GENERAL NOTES

FRA - 270-51.50

ADDENDUM #4
05/08/2023

CULVERT DETAIL SHEET
96" PIPE WITH MITERED EDGE

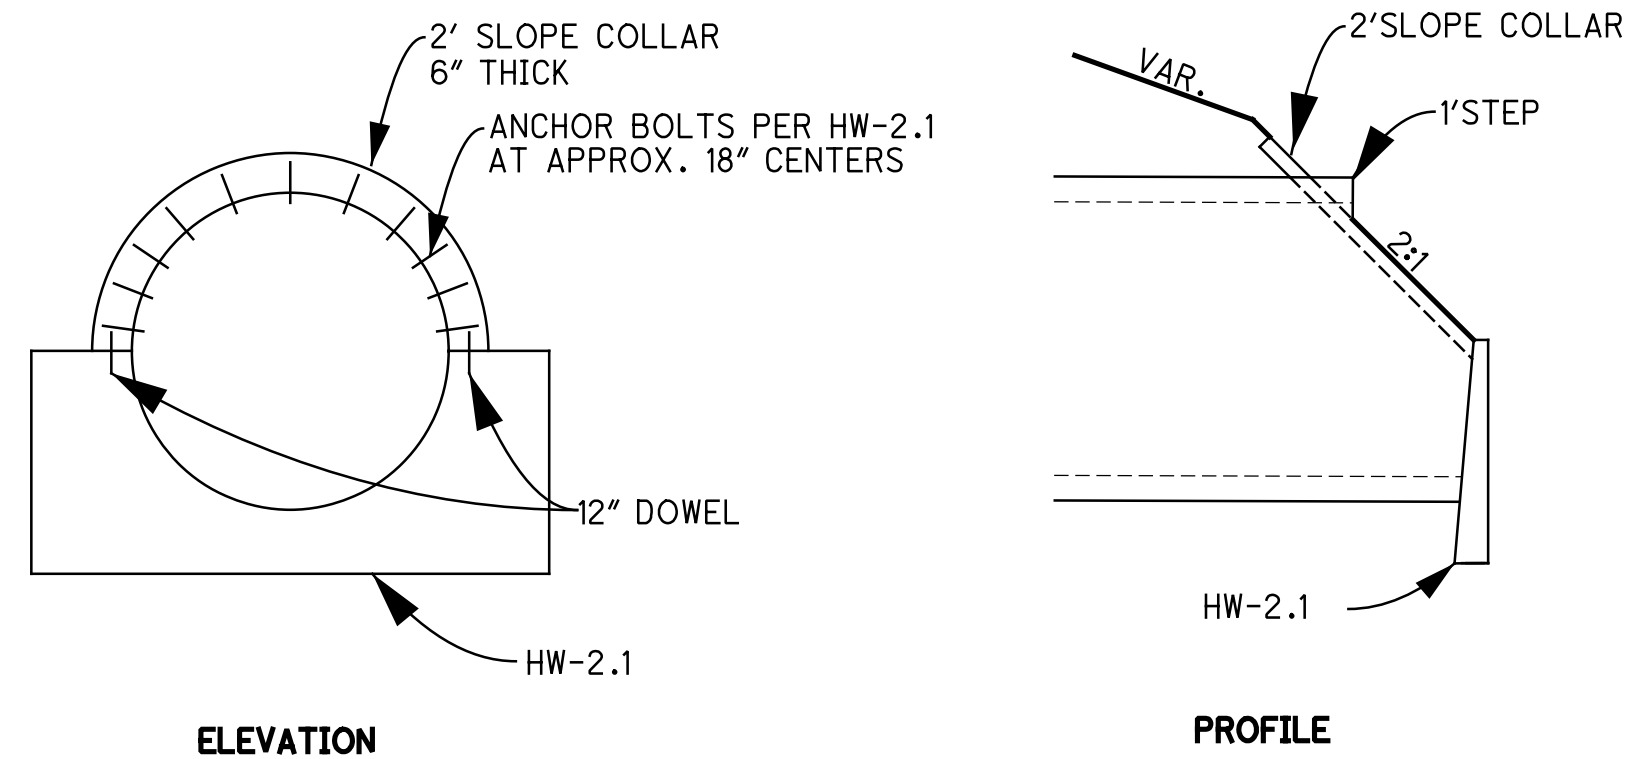
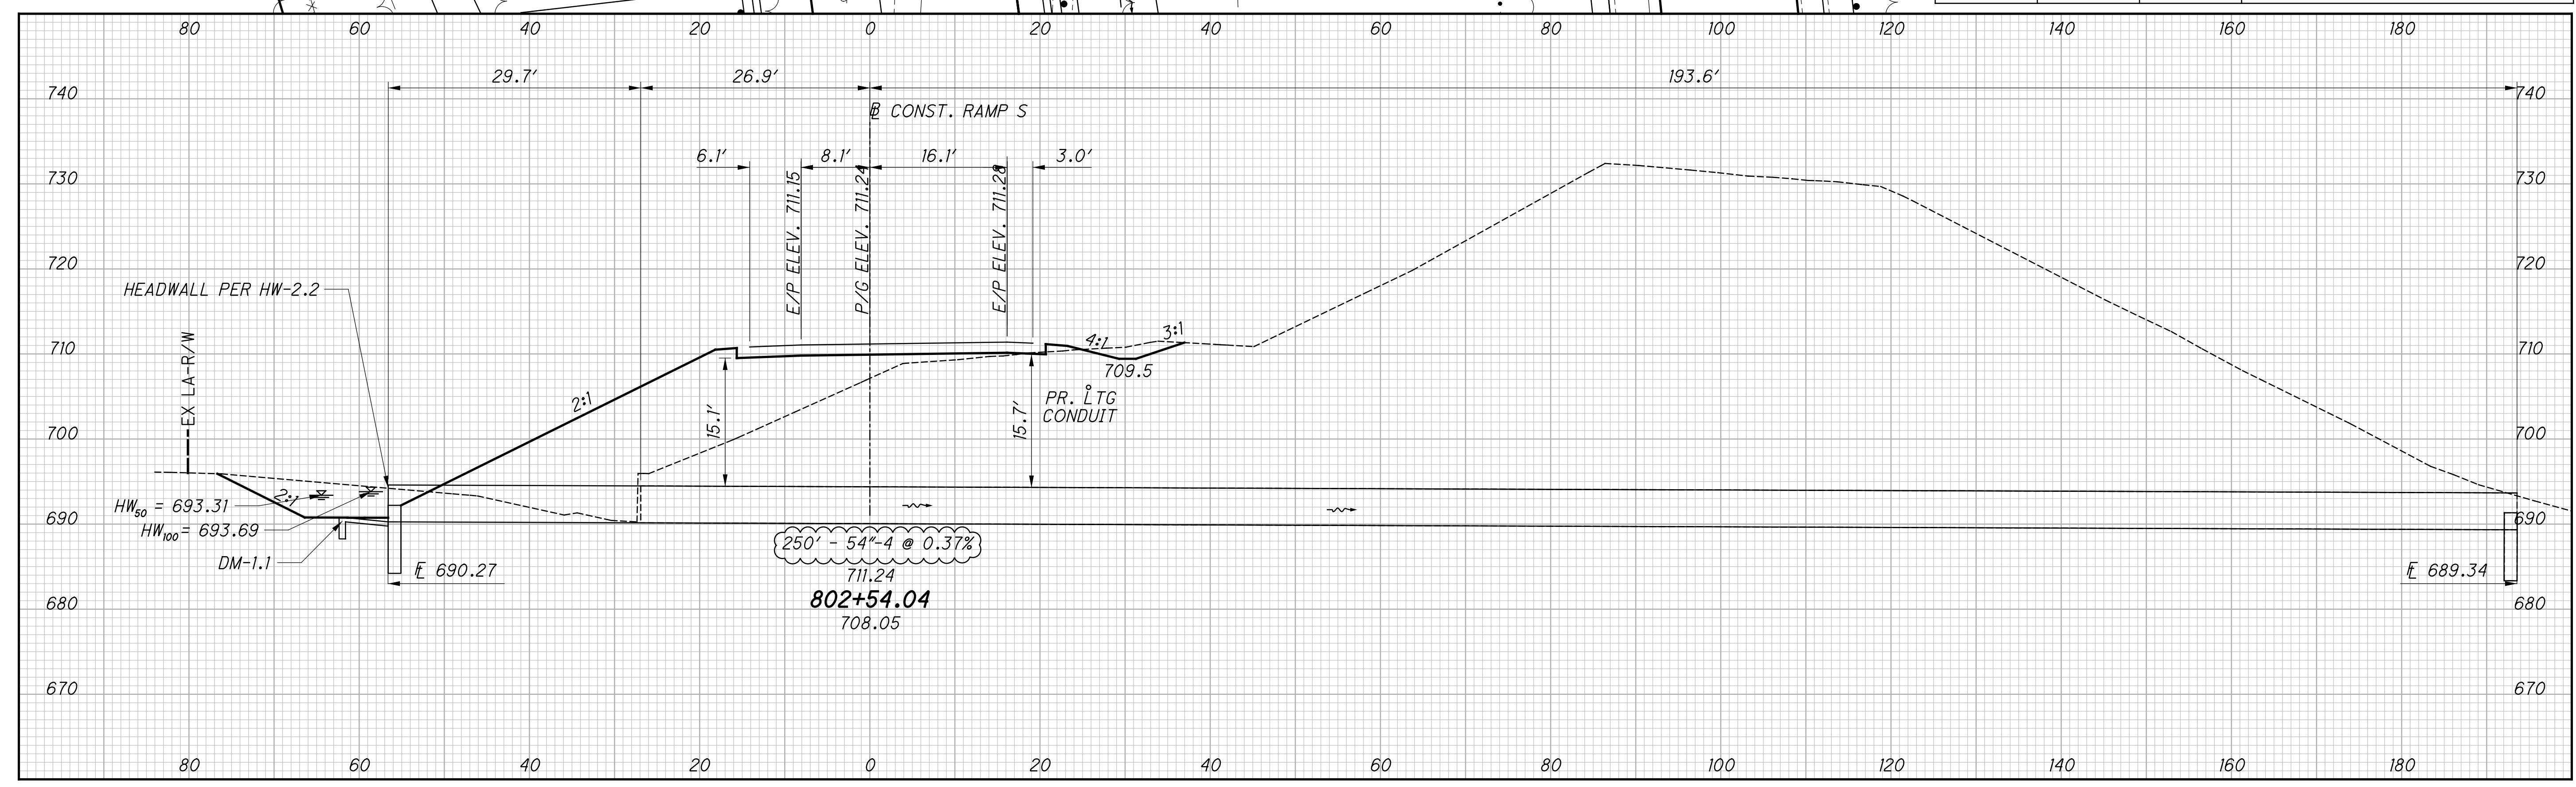
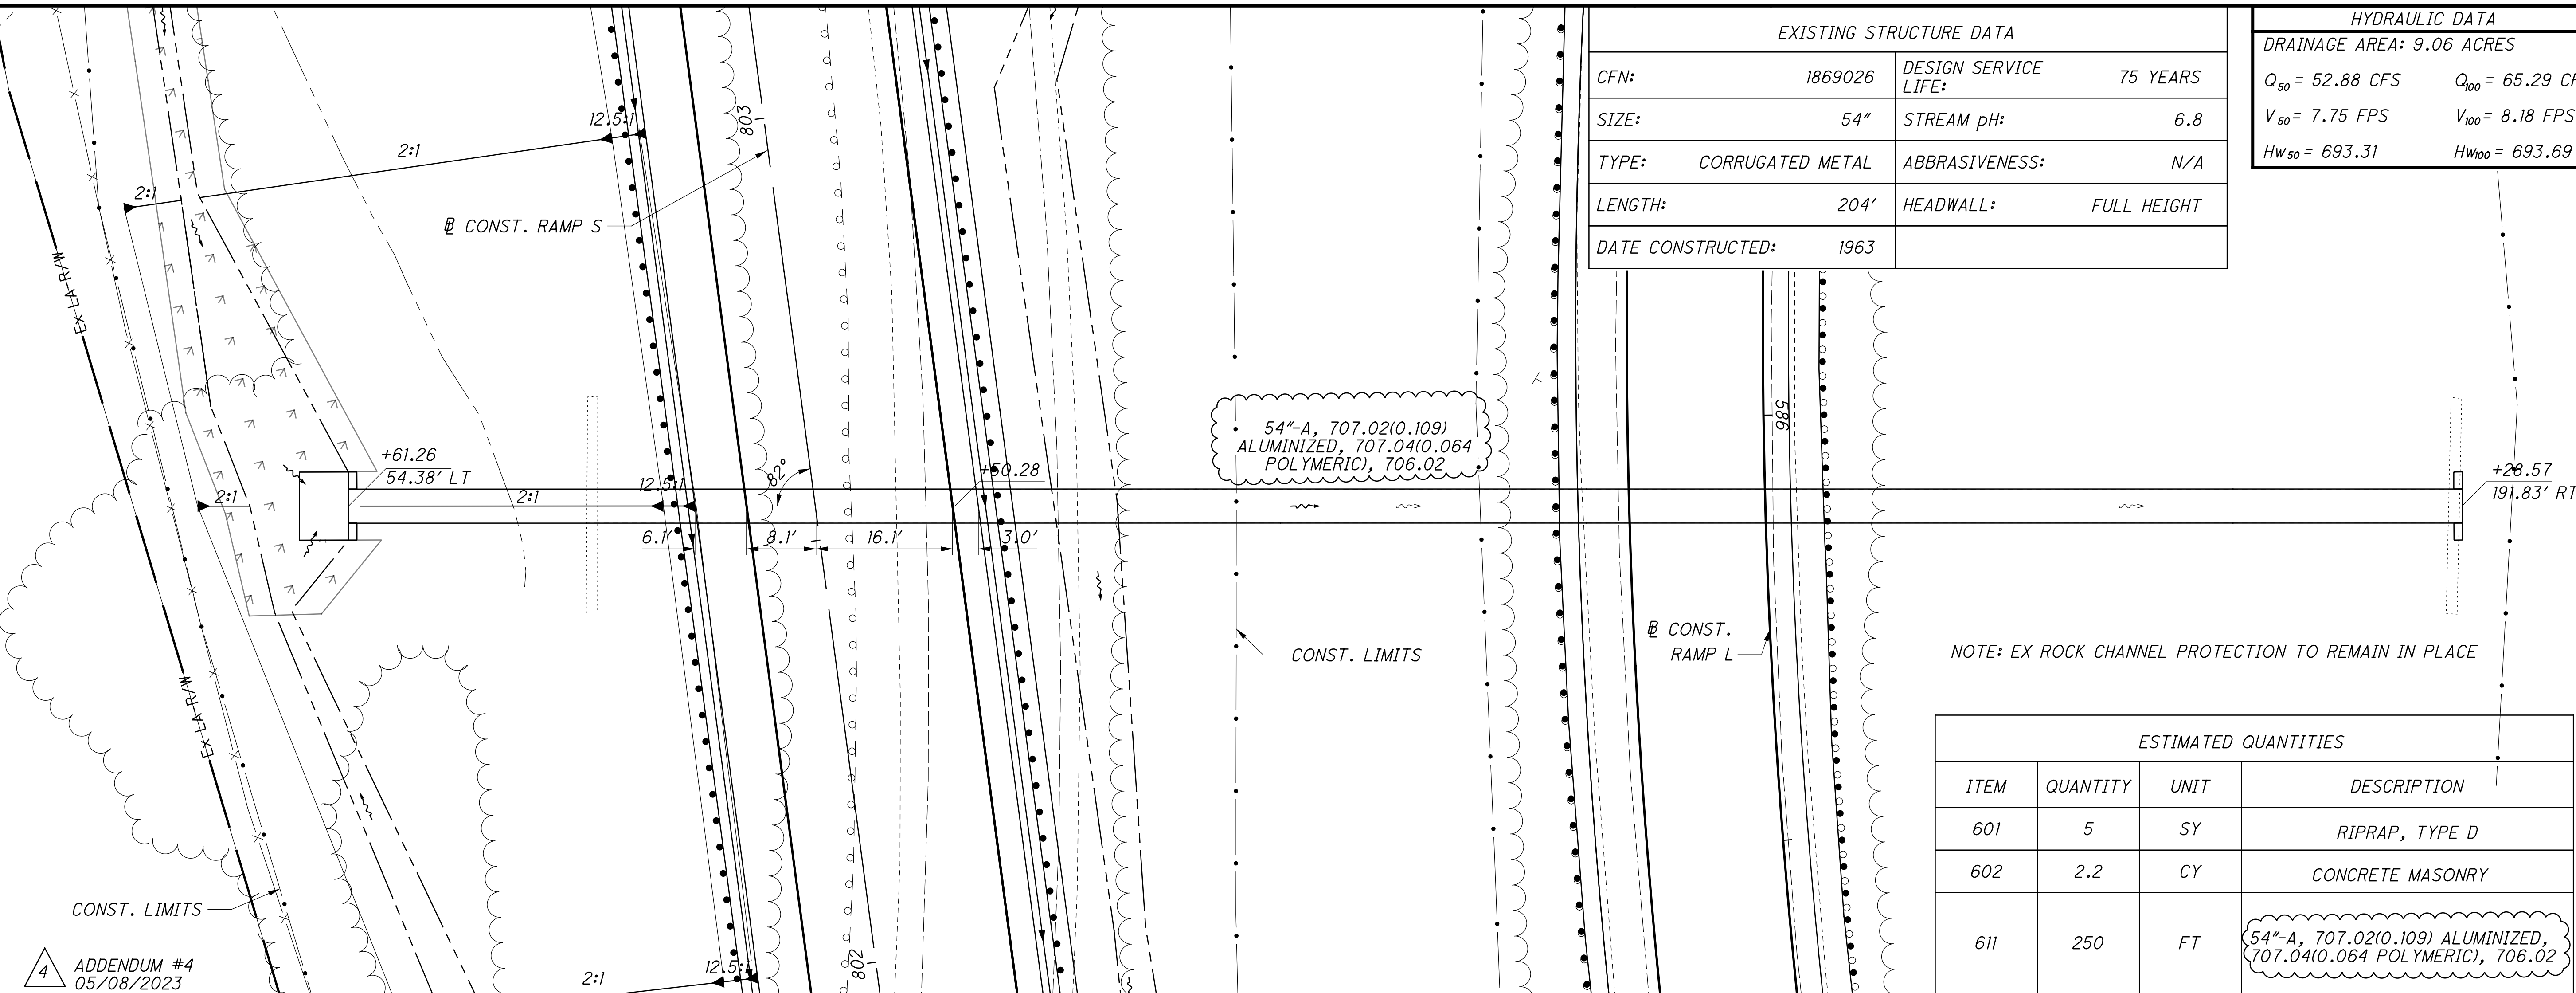
ITEM 611 96" CONDUIT, TYPE A, AS PER PLAN 707.03(0.249)

THE ABOVE CONDUIT SHALL BE MITER-CUT(STEP-BEVEL) TO FIT THE EMBANKMENT SLOPE. FOR THE DETAILS AND QUANTITIES FOR THE MITER-CUT(STEP-BEVEL) END SECTIONS, SEE SHEETS 78 AND 372, RESPECTIVELY.

THE MATERIAL USED FOR THE BEDDING AND BACKFILL IS LIMITED TO ITEM 603 GRANULAR MATERIAL TYPE 1. IT SHALL BE COMPACTED PER 603.081 METHOD A.

THE CONTRACTOR SHALL PROVIDE A MANUFACTURER'S REPRESENTATIVE WHO SHALL BE RESPONSIBLE FOR THE ERECTION OF THE CULVERT.

THE STRUCTURE SHALL BE EXTERNALLY COATED PER AASHTO M243.

THE CONTRACTOR SHALL PROVIDE A MANUFACTURER'S REPRESENTATIVE WHO SHALL THROUGH THE ENGINEER, INSPECT, TEST, REJECT, OR APPROVE THE FILL MATERIAL AND ITS PLACEMENT. THE REPRESENTATIVE SHALL ALSO MONITOR THE CONDUIT DURING ITS ASSEMBLY AND ERECTION TO MAKE CERTAIN THE STRUCTURE IS SYMMETRICAL AND PROPERLY SHAPED. THE REPRESENTATIVE SHALL ALSO MONITOR THE SHAPE FOR ANY DISTORTION OF THE THE CONDUIT DURING THE PLACING OF FILL TO ENSURE ANY MOVEMENT OR DISTORTION IS WITHIN THE MANUFACTURER'S TOLERANCE RANGE.
